STATE OF HAWAII
DEPARTMENT OF TRANSPORTATION
HIGHWAYS DIVISION
UTILITY PLAN
MAUNA KEA MAINTENANCE
BASEYARD
DANIEL K. INOUE HIGHWAY
Project No. 200A-01-10
Scale: As Shown Date: April, 2018

1	06-07-18	ADDENDUM NO. 4	
REVISION	DATE	DESCRIPTION	AA15

STATE OF HAWAII
DEPARTMENT OF TRANSPORTATION
HIGHWAYS DIVISION
SHOP BUILDING
MAUNA KEA MAINTENANCE BASEYARD
DANIEL K. INOUE HIGHWAY
Project No. 200A-01-10

C-13

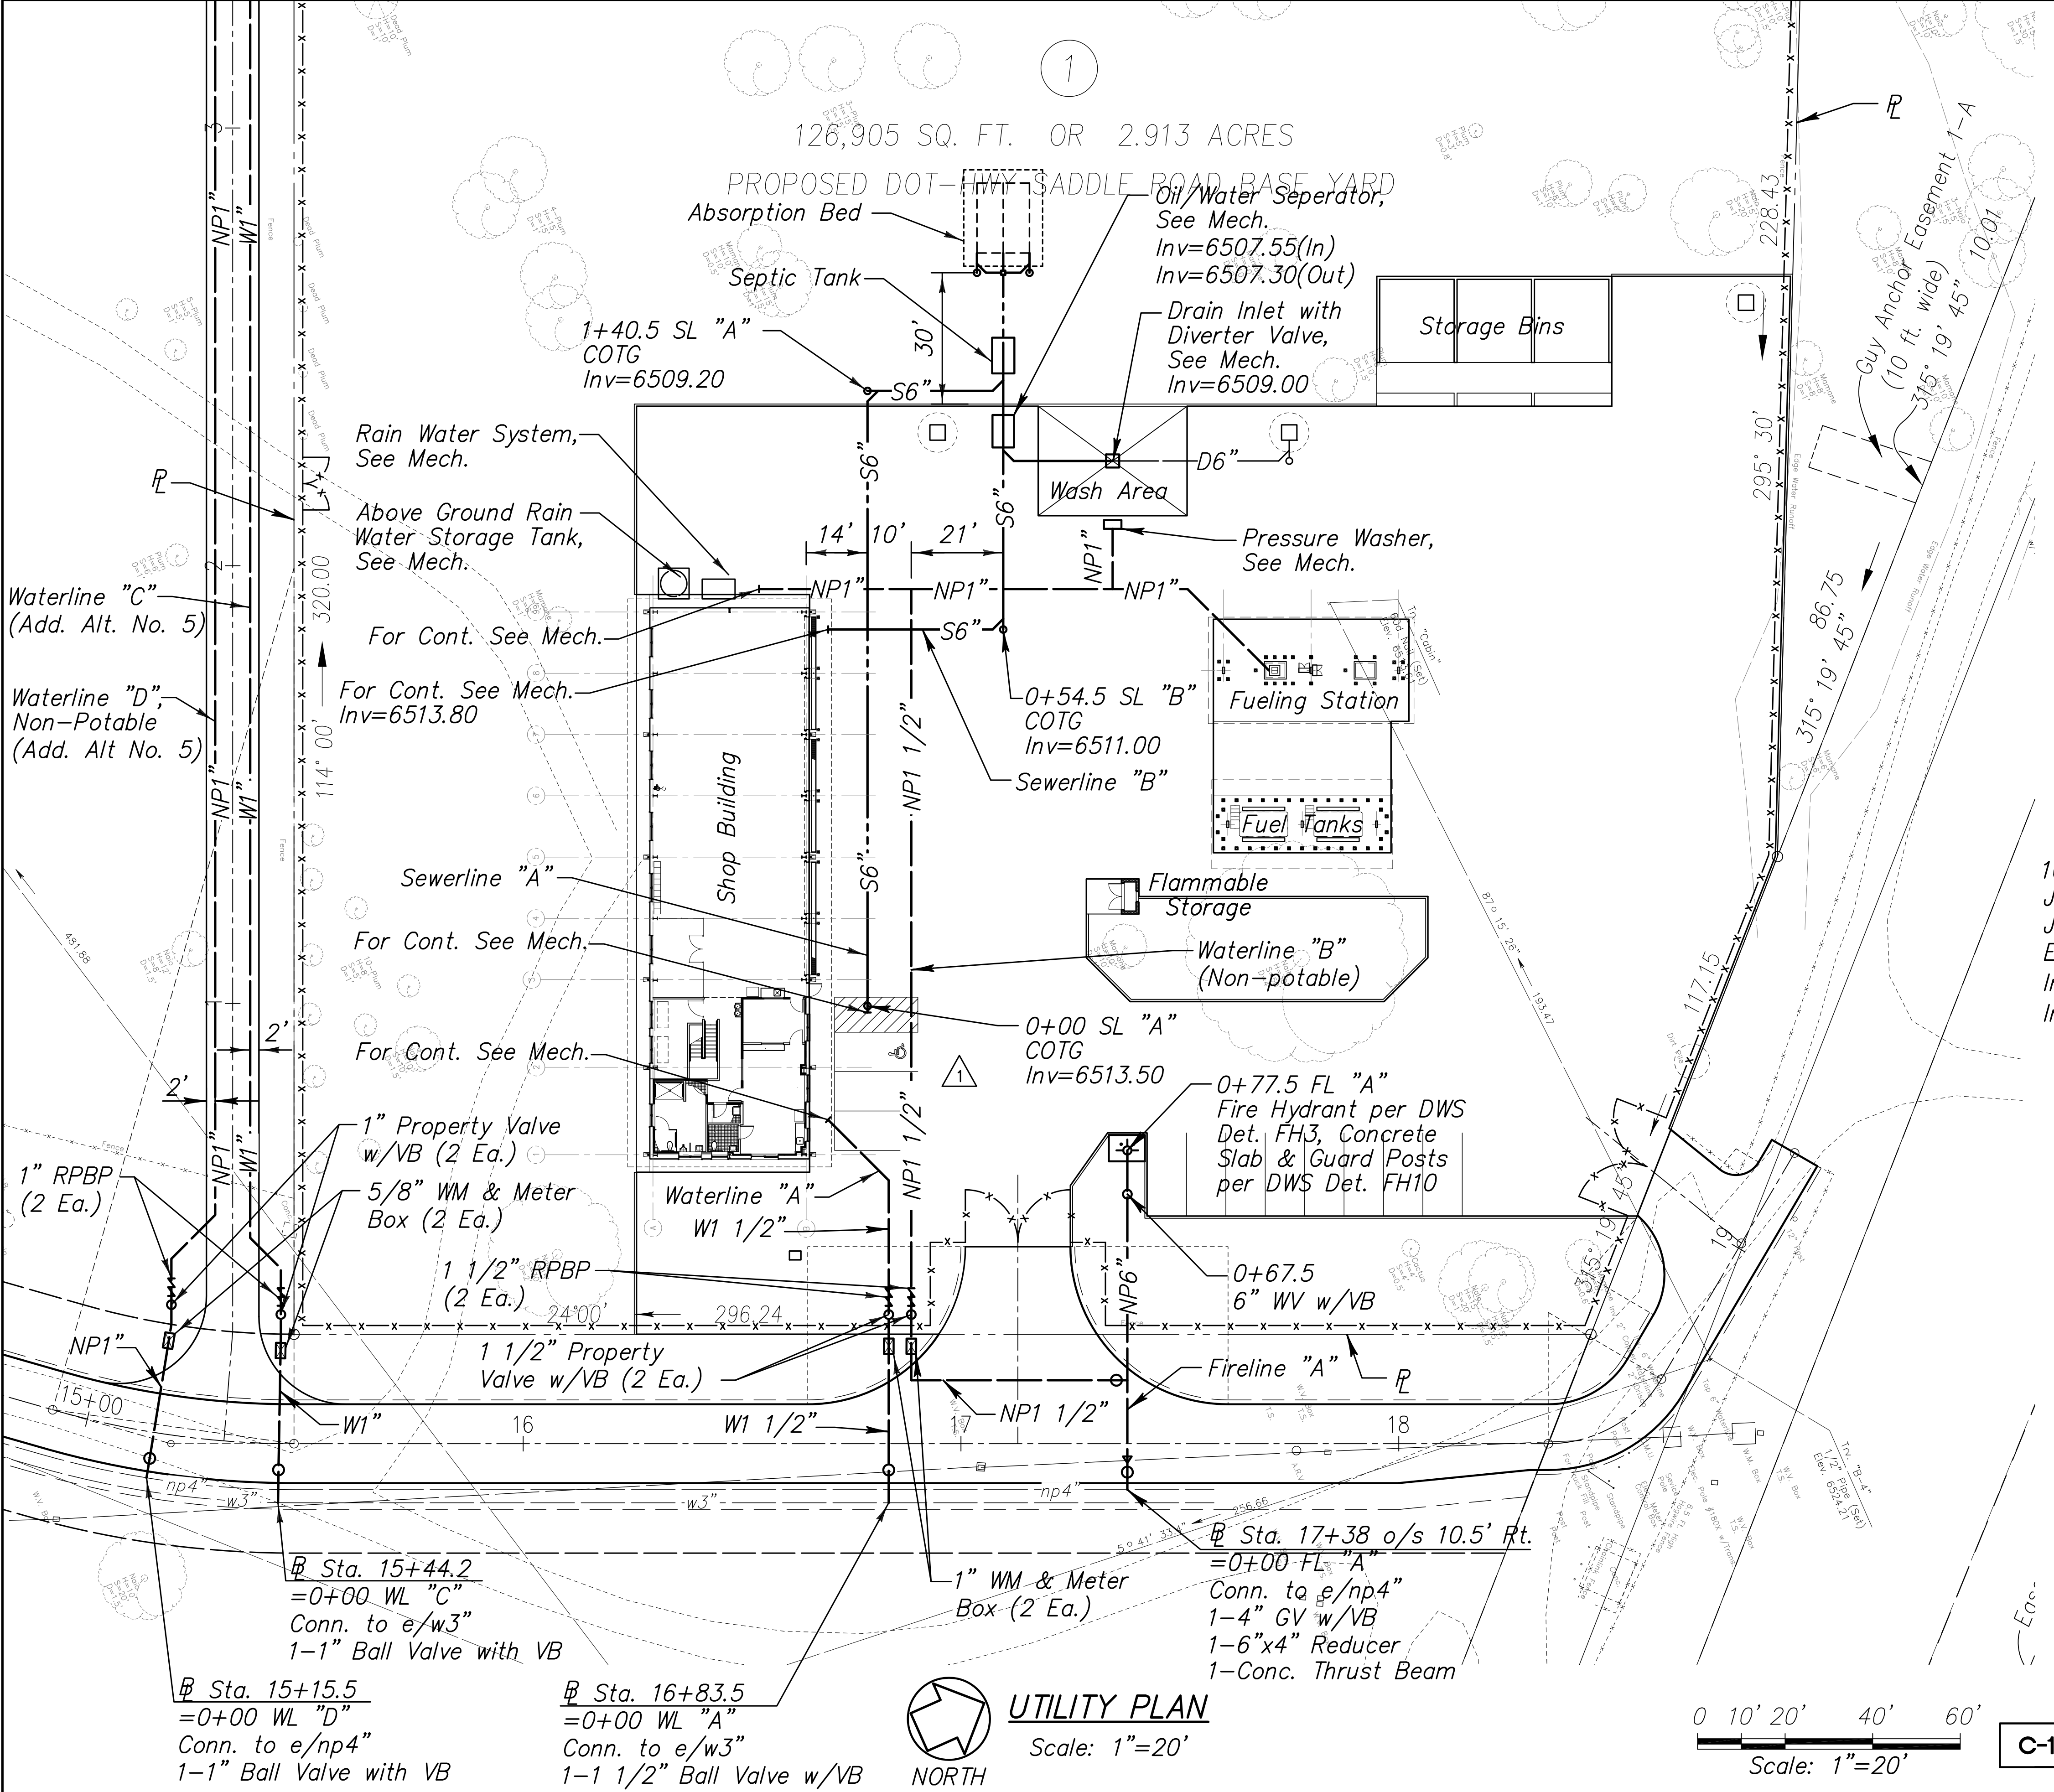
06-07-18	1 REVISED NP WATER & SEWER
DATE	REVISION

DETAIL FLOOR PLAN
SCALE: 3/8" = 1'-0"

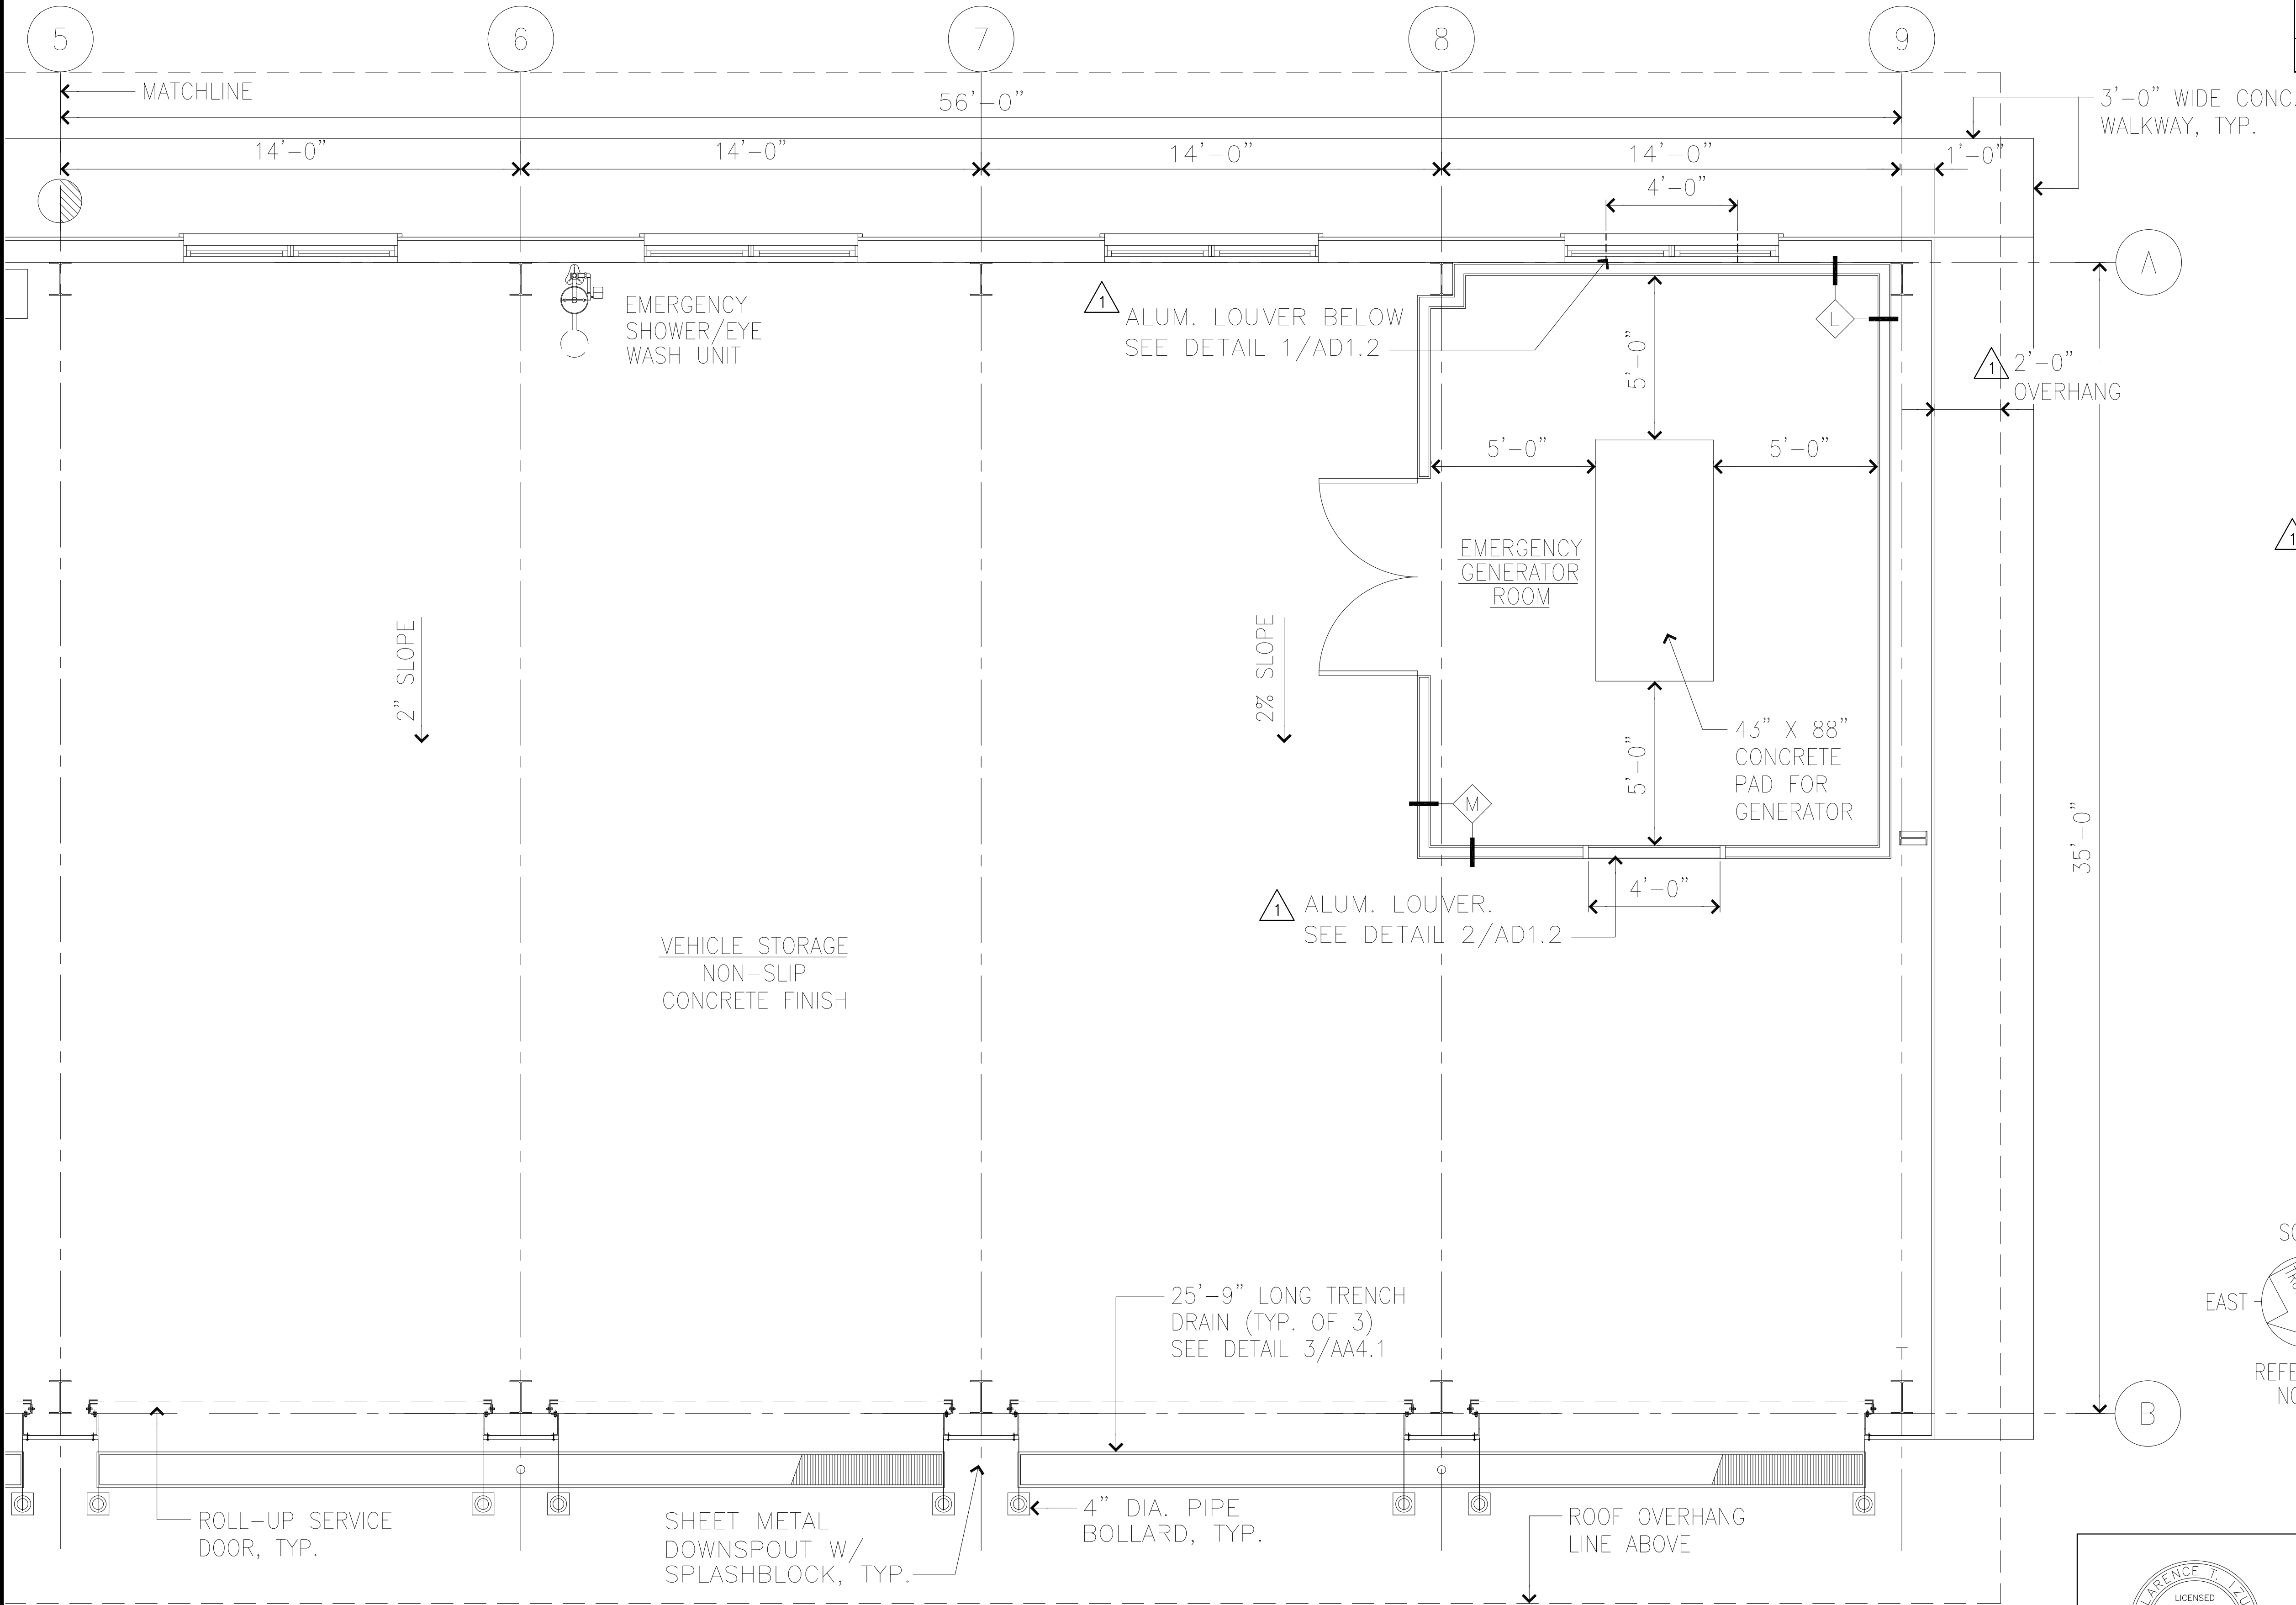
06-07-18	1	ADD LOUVERS, ROOF OVERHANG DIMENSION, & LOUVER NOTE
DATE	REVISION	
STATE OF HAWAII DEPARTMENT OF TRANSPORTATION HIGHWAYS DIVISION <u>SHOP BUILDING</u> <u>MAUNA KEA MAINTENANCE</u> <u>BASEYARD</u> <u>DANIEL K. INOUE HIGHWAY</u> <u>Project No. 200A-01-10</u> Scale: As noted Date: April 2018		
SHEET No. AA1.5 OF 46 SHEETS

NOTE:
PROVIDE 6 SQ. FT. FREE AREA
FOR EACH LOUVER SHOWN IN
EMERGENCY GENERATOR ROOM.

AA2.1

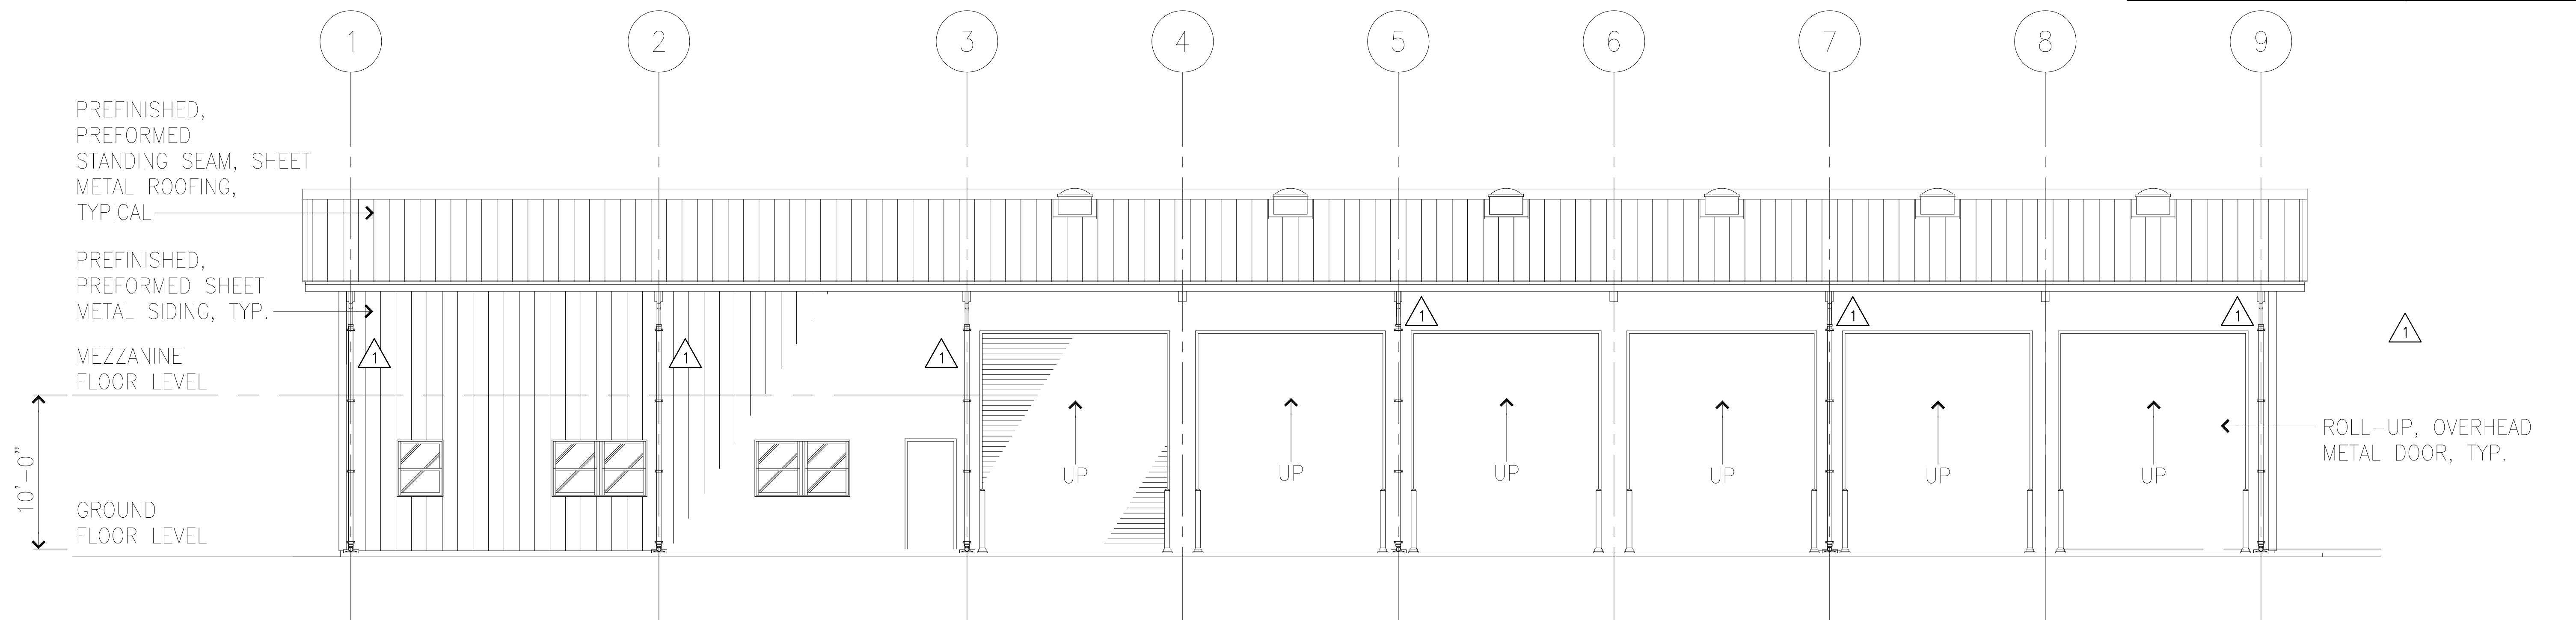
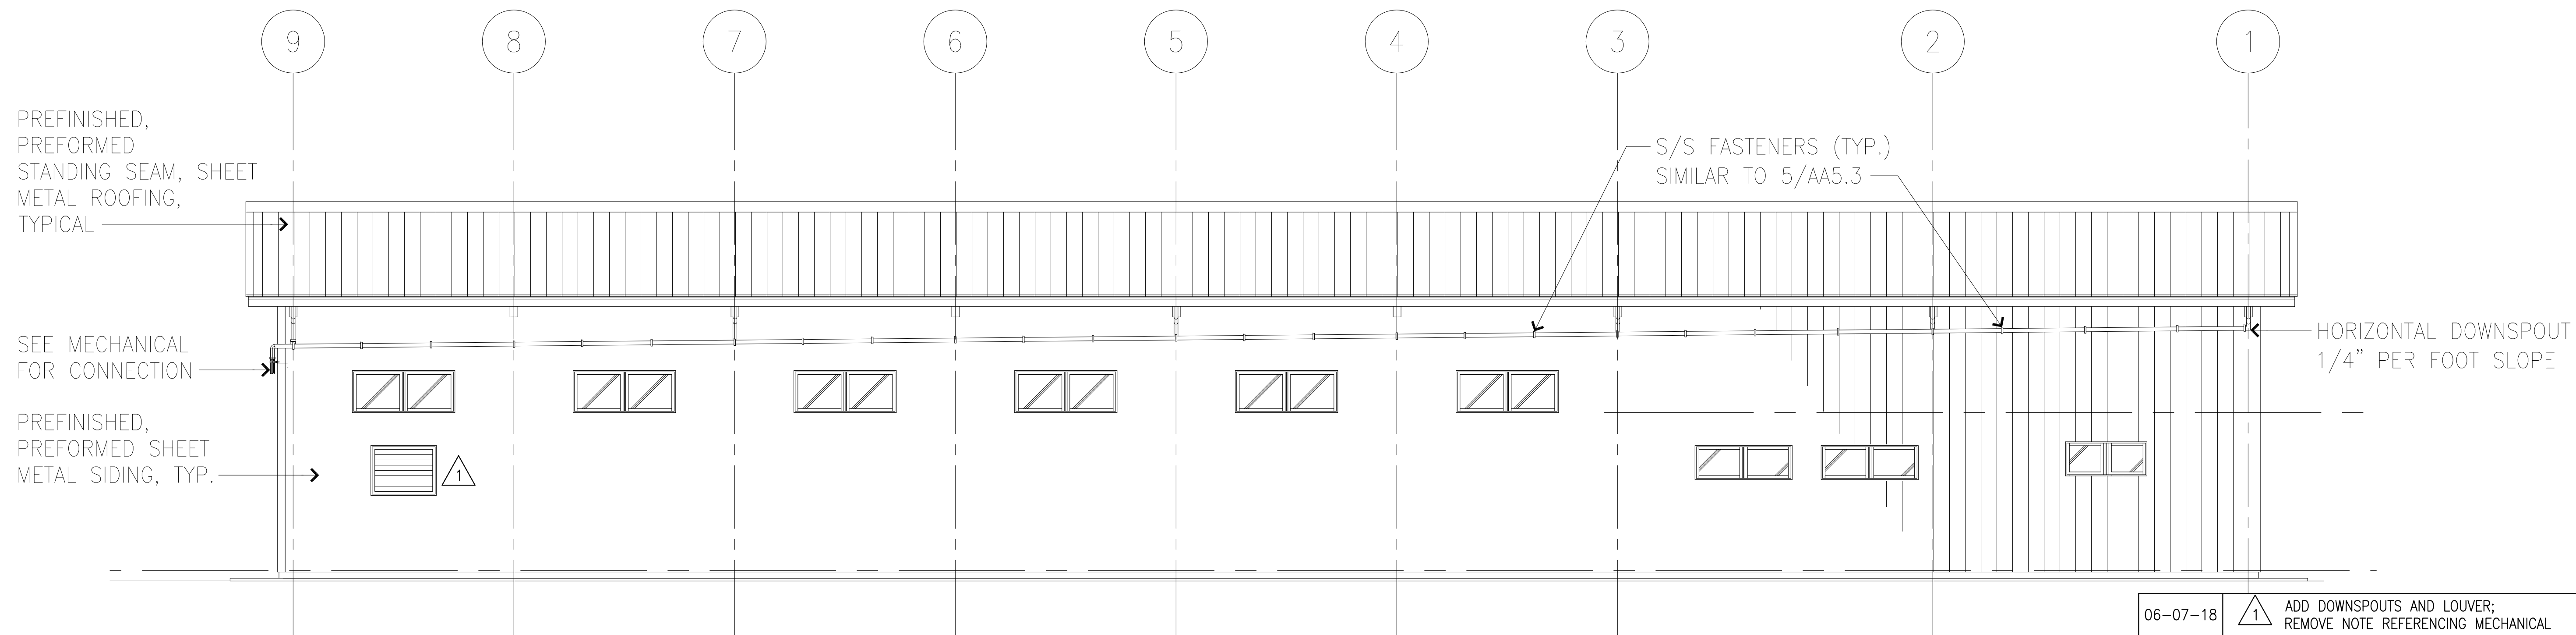
06-07-18	1	ADD DOWNSPOUTS AND LOUVER; REMOVE NOTE REFERENCING MECHANICAL
DATE	REVISION
